**Asciano Submission to the QCA on QR Network DAAU Relating to Electric Traction**

# **QR Network Draft Amending Access Undertaking – Electric Traction Services**

**Asciano Submission to the QCA**

### **Asciano - Above rail consist requirements**

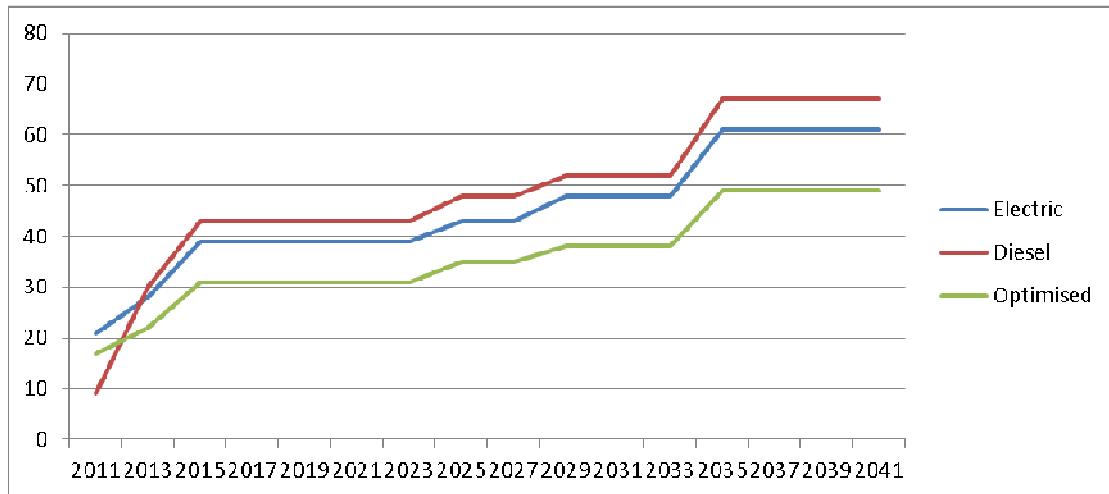
based on Asciano's replication of the QR Network analysis as far as Asciano was able to do so and the "optimised line" is the line that is based on actual Asciano Diesel cycle performance and train consists at 116 wagons. This shows that better performance could be achieved by a more efficient fleet of diesel train consists at more optimal load than electric units.

As such this analysis further brings into question the validity of QR Network's analysis.

**Figure A.2: Growth and maintenance capital expenditure (Blackwater, \$)**

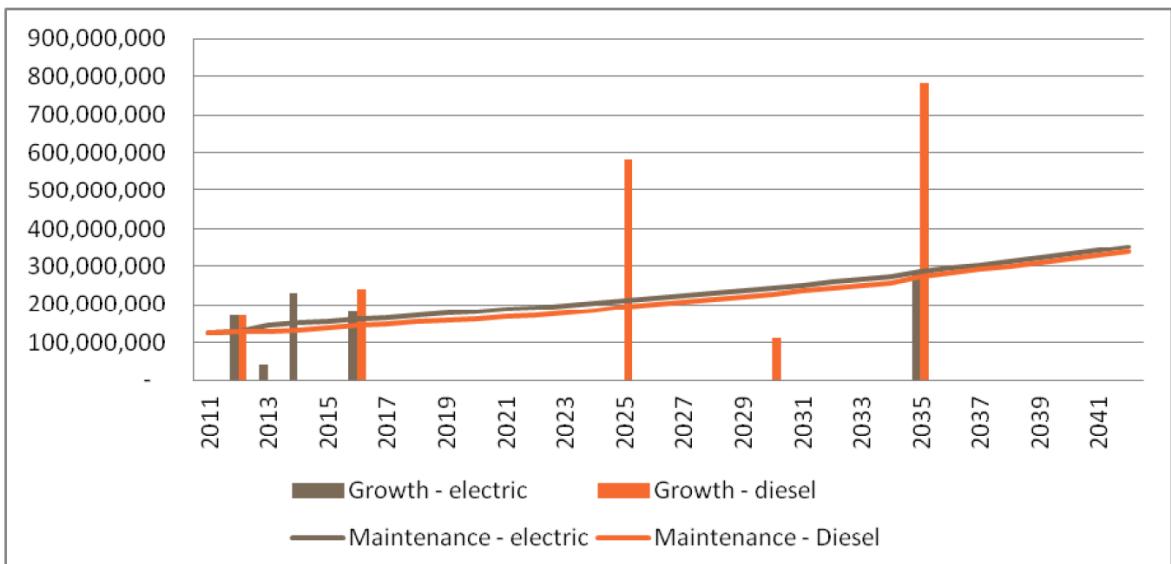
46. In order to see why, consider Figure A.2 from QR Network’s submission, reproduced below.

47. The significant increases in below rail capital expenditure under the diesel scenario occur in 2025 (around \$600m) and 2035 (around \$800m). In fact, prior to 2025 there is a materially higher expenditure on expanded electrification (with around \$200m higher investment in the electrification scenario before 2016). That is, the savings in capex under the electric scenario only occur in the distant future while there are significant upfront costs (including the \$346m electrification costs not included in the model and over \$200m in higher net costs to be incurred over the next few years that are included in the model). Figure A.2 also shows additional operating and maintenance costs for the electric infrastructure begins immediately after the infrastructure investment.
